**Government of India
Ministry of Railways
Research, Designs & Standards Organisation
Manak Nagar, Lucknow - 226 011**

**SPECIAL MAINTENANCE INSTRUCTIONS NO.
RDSO/ELRS/SMI/118**

**TIGHTENING OF CONNECTING TERMINAL (1206) WITH NUT (1207) ON
CONTACT PINS (1208 & 1209) OF TAP CHANGER NO. 32 OF HBB MAKE**

TERMINAL ASSEMBLY WITH NUTS (TAP CHANGER NO.32)

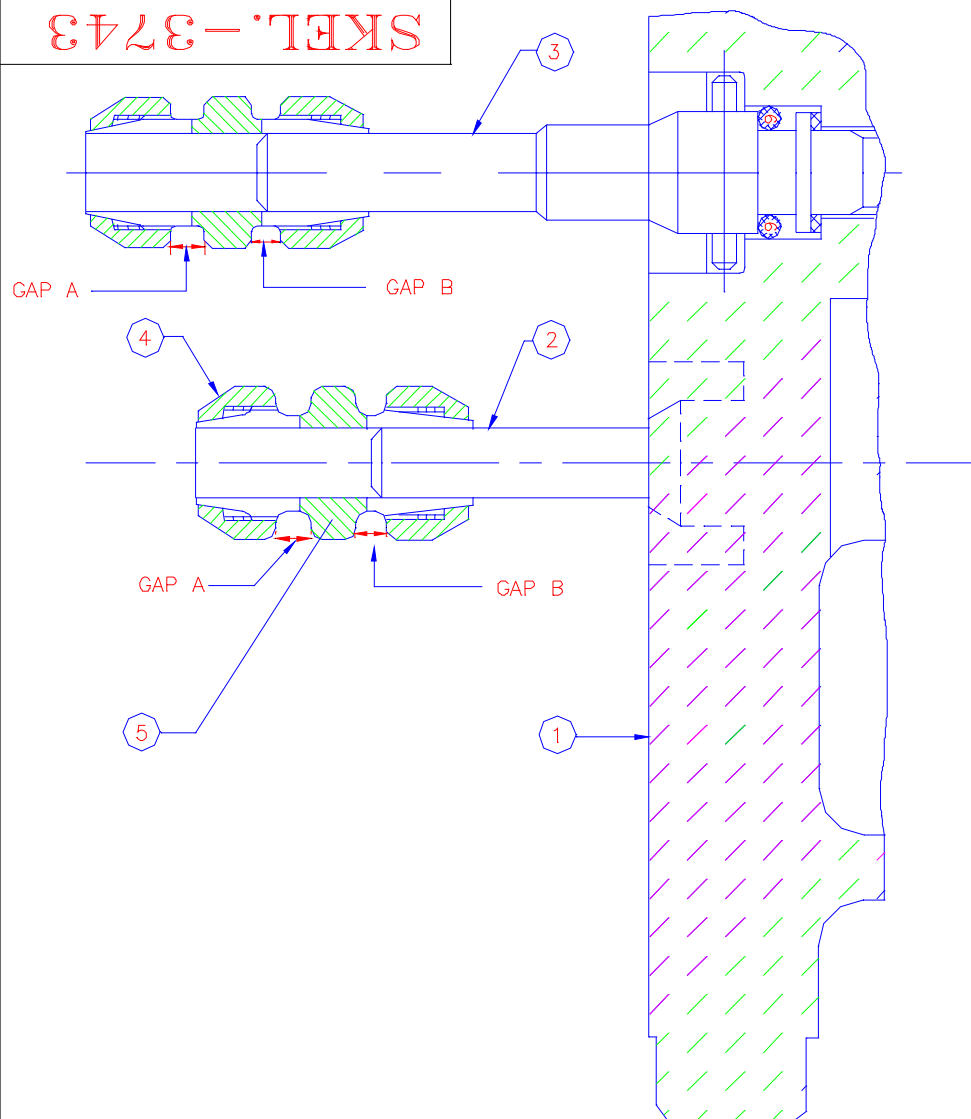
Railways have reported a few cases of overheating at the joints of terminals. Investigations has shown that this was due to the defective nuts used during terminal assembly of stage III tap changer at HBB works, with the result the terminal assembly got loose and overheated in service.

- Tighten the Nut (1207) to terminal on contact pins (1208 & 1209)_ with a torque of 1.4 kg.m.
- Maintain a minimum gap of 2.5 mm between terminal face and nut face i.e. Gap B = 2.5 mm (min)
- Similarly tighten the nut on the transformer pins with a torque of 1.4 kg. m.
- Maintain a minimum gap of 2.5mm between terminal face and nut face i.e. Gap A = 2.5 mm (min)

- Note :**
- i) Reduced gap A & B can be permitted especially if the torque 1.4 kg.m. is maintained for successive tightening. If there is no gap, the nut is to be replaced by a new nut, to be obtained from M/s HBB
 - ii) Connectors are now being checked using a dummy plug and full tightening of nut is ensured by M/s HBB from tap changer No. 31180130 onwards.
